Morlais Project

Benthic and Intertidal Ecology Issues Responses to NRW comments

Morlais Document No.
MOR/RHDHV/DOC/0113

Date:
25/03/2020

Figure: 9-1 Drawing No: PB5034-ES-009-001

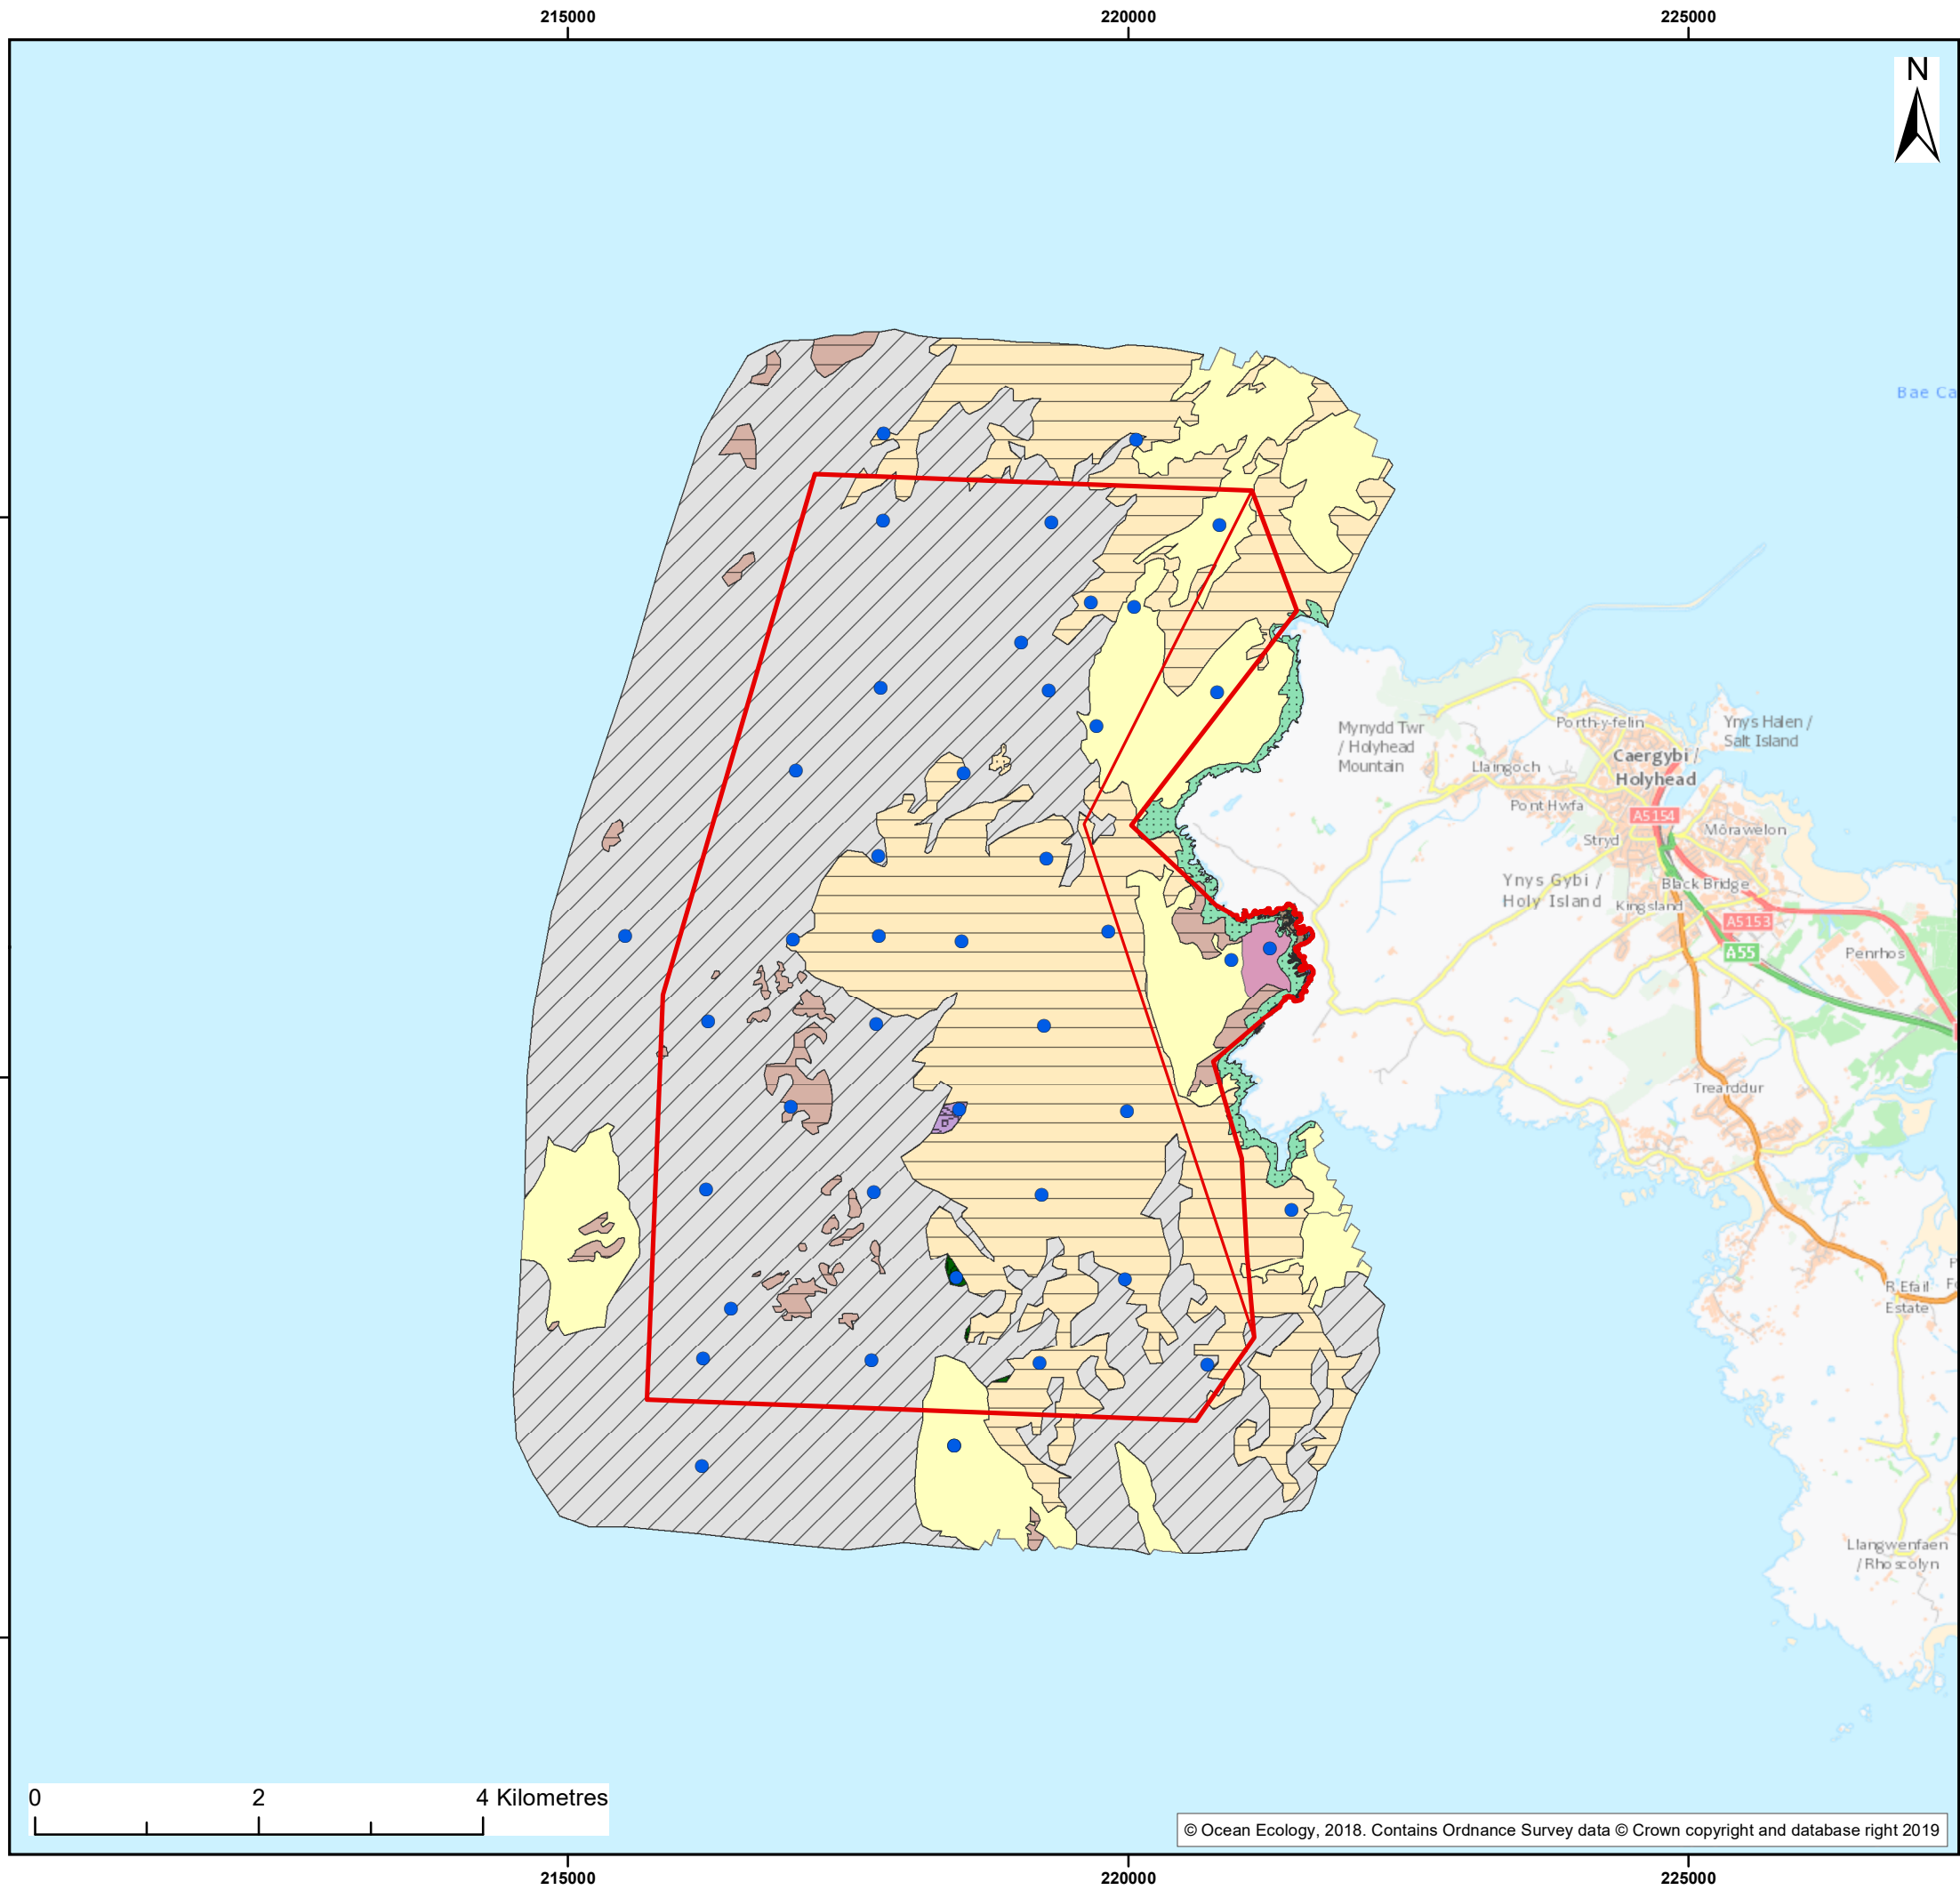
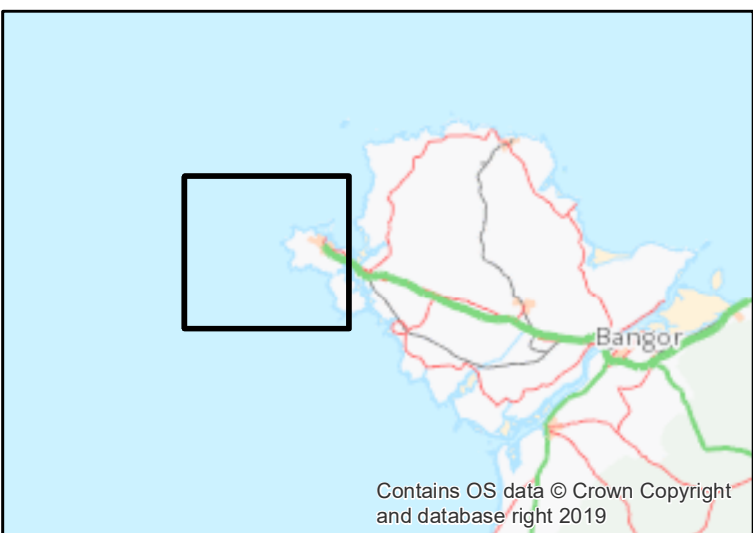
70 | Table 9-3: Whilst there is multibeam information for the Offshore Scoping Zone, biotopes, Valued Ecological Receptor (VER) groups, Drop Down Video (DDV) stations and habitat types for this area these should also be shown on Figure 7-2, Volume II, ES in order to understand any likely impacts in this area.

95 | Figure 9-3: The EUNIS codes shown in the legend are restricted to those visible on the maps. We acknowledge this has been presented to encompass both the subtidal and intertidal plates, but it would be easier to visualise what is depicted on the maps if there were separate legends for the subtidal biotope map and the intertidal one (so there would be fewer similar colours); this would aid the determination of the main biotopes present.

The Applicant suggests this is best shown in the relevant Chapter 9 figures as the DDV is of most relevance to benthic ecology rather than Metocean Conditions and Coastal Processes (Chapter 7). The DDV locations have been added to updated versions of Figure 9-1 and Figure 9-2, provided with this submission.

Figures 9-1 and 9-2 have been updated to group the EUNIS habitats by subtidal and intertidal and include locations of sample stations.

Figure: 9-3 Drawing No: PB5034-ES-009-003

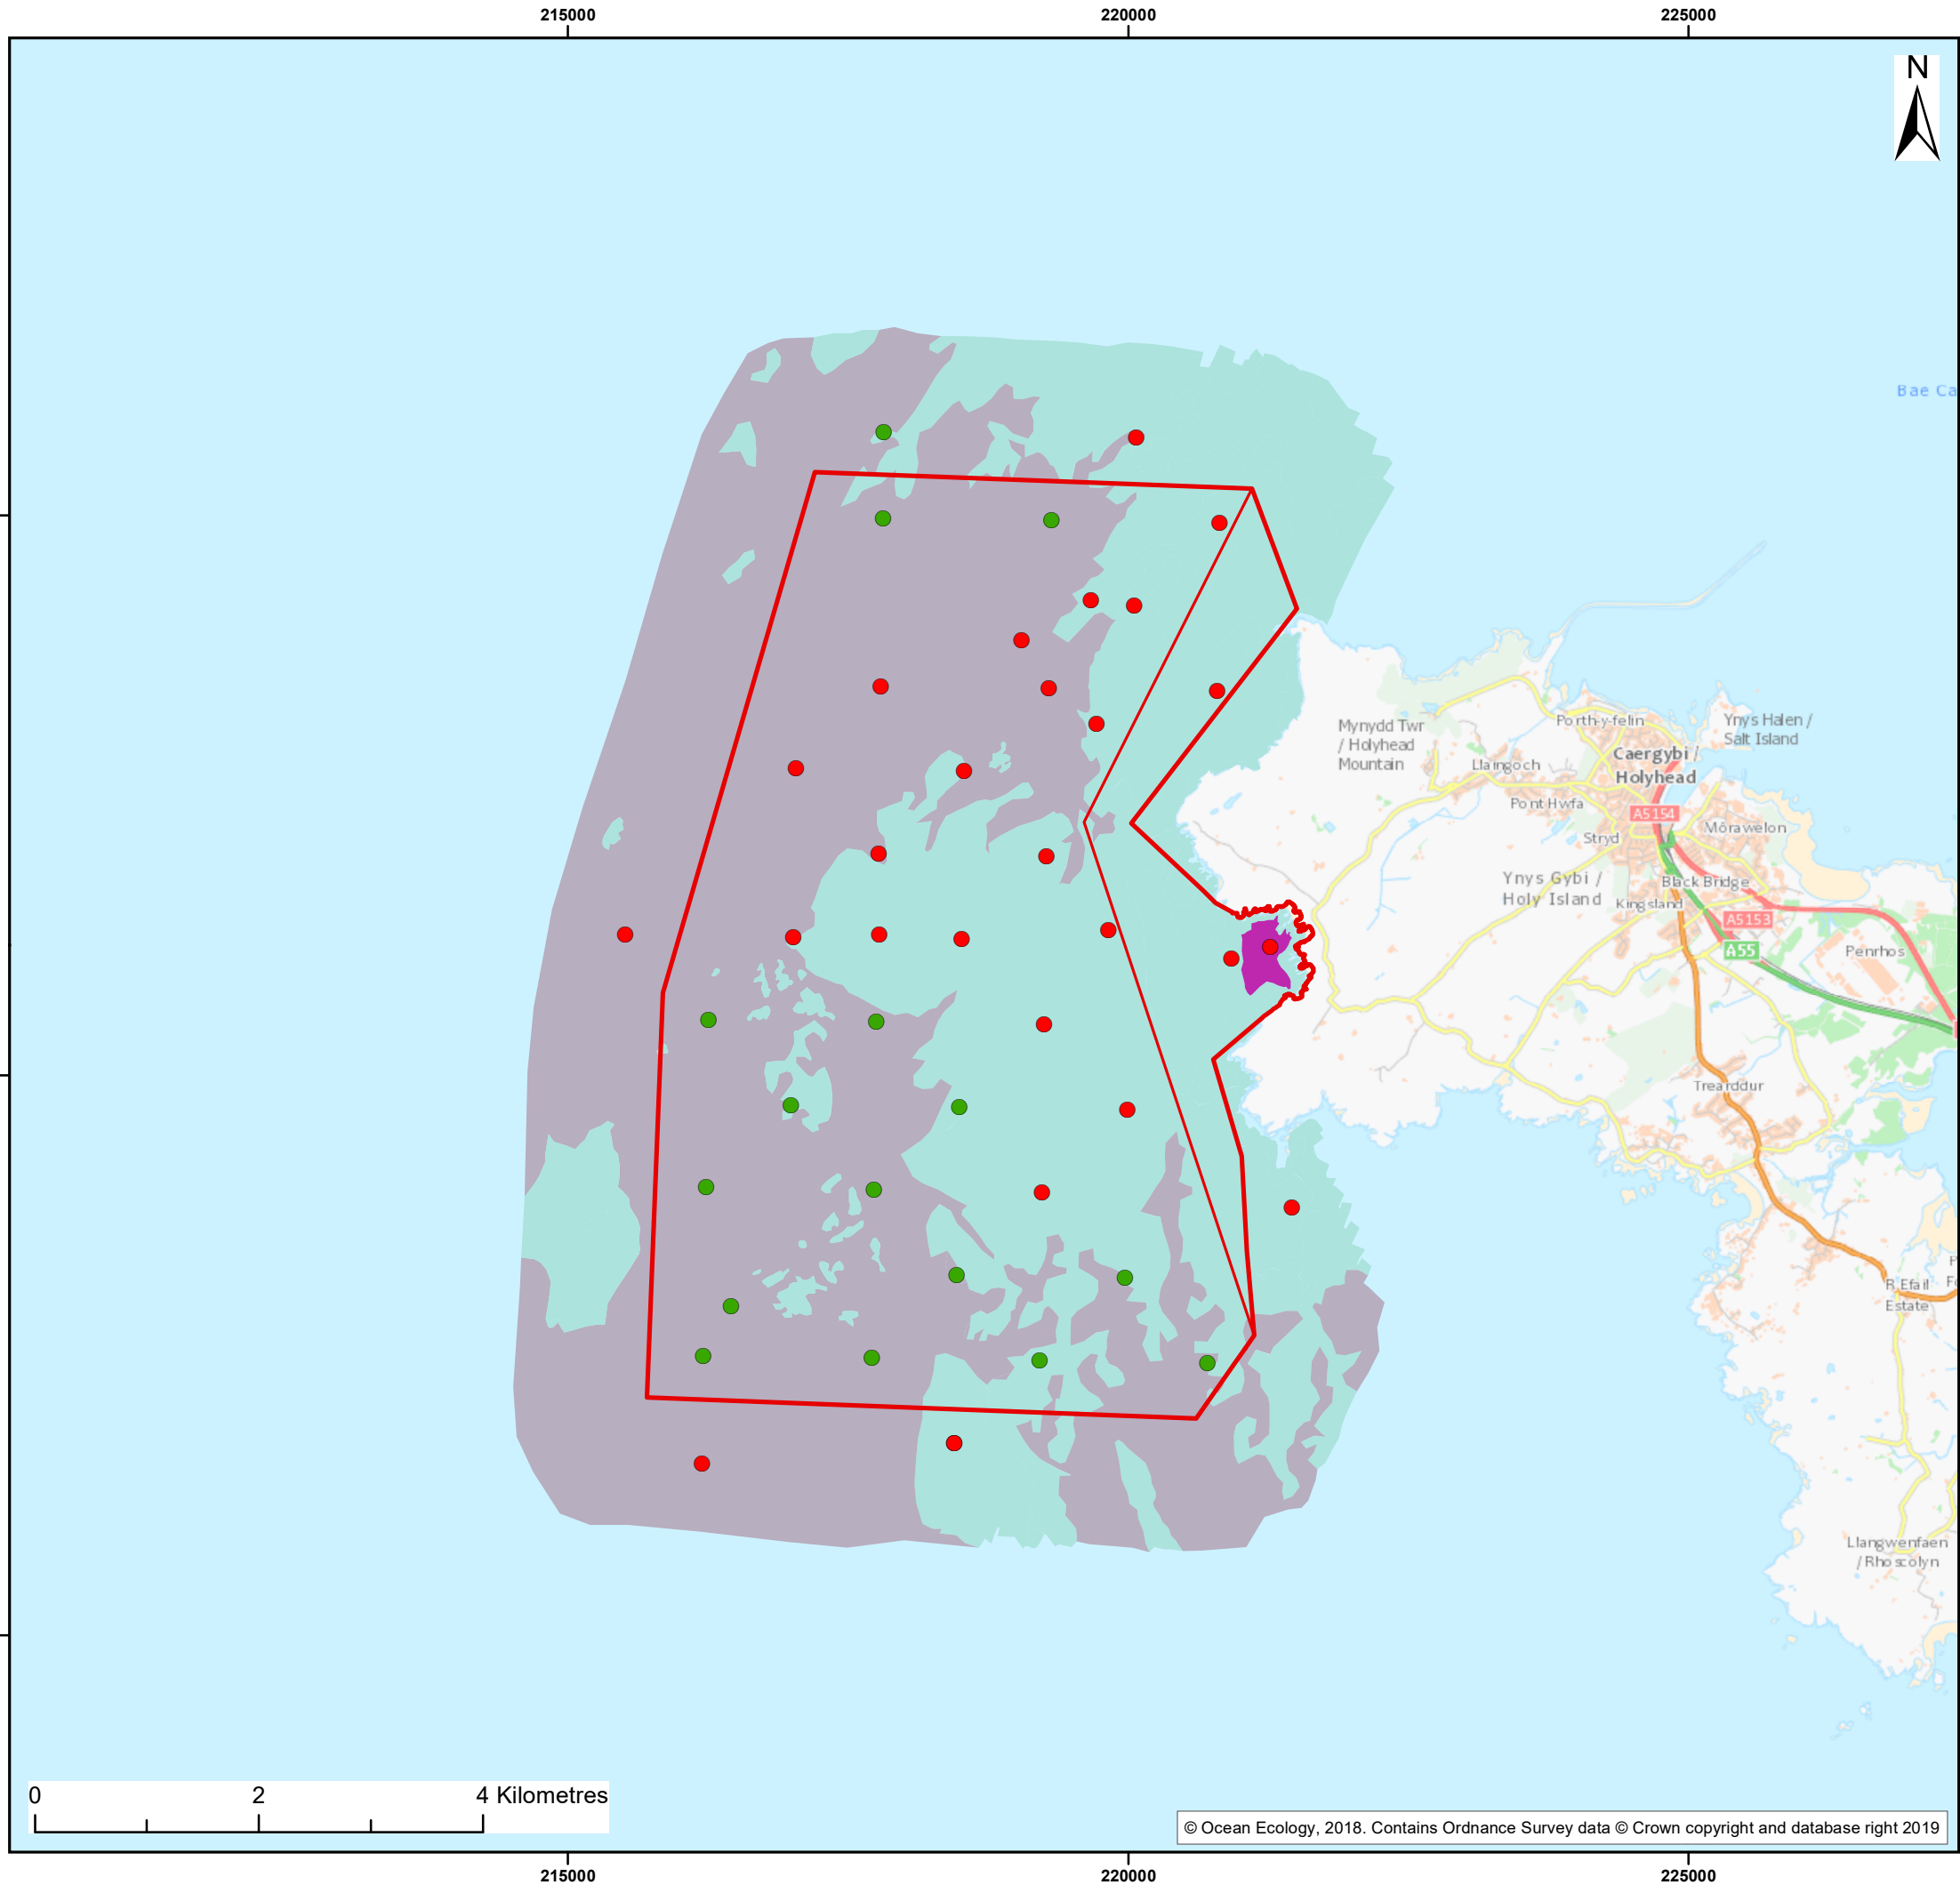
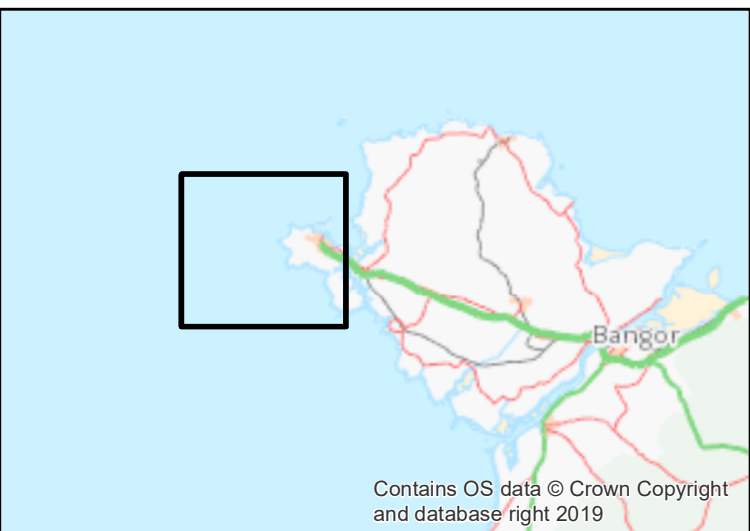
84 | Section 9.6.3.1 - Operational Impact 1: Long Term Loss of Benthic Habitat via (a) Initial Placement of Project Infrastructure and (b) Repowering: In the absence of an accurate assessment of the benthic habitats present in the MDZ it is not possible to agree with the downgrading from 'Moderate' adverse to 'Minor' adverse. The assessment is based on a proposal to conduct post-consent, pre-construction surveys to 'micro-site' project infrastructure. However, in the absence of detailed habitat surveys it is not possible to assess whether the mitigation approach is feasible based on the scale of the proposal and extent of habitats of conservation importance present.

93 | Figure 7-2: It is unclear how the habitat types shown in Figure 7-2 have been determined. Therefore, more detail is required as the information present appears to under-represent the extent of *Sabellaria* habitat (Annex 1 biogenic reef and Section 7 Habitat) present. Review of the raw species data shows notable abundance of *Sabellaria* at stations 2, 3, 4, 5, 6, 8 etc.

Figure 9-3 has been updated to show the sampling stations where *S. spinulosa* reefs were recorded overlaid on to the VER habitat group maps. As can be seen from this updated figure, there is not blanket distribution of reefs throughout VER habitat group 10. As the distribution of reef habitat is patchier than the VER habitat mapping would suggest, micro-siting will be possible throughout most

Locations where *Sabellaria* reef was recorded during the project benthic survey are shown in the updated Figure 9-3 as *Sabellaria* reef is of most relevance to Chapter 9, Benthic and Intertidal Ecology.

Figure 9-3 has been updated to remove intertidal VERs and include sample stations where *S. spinulosa* reef was present/absent.
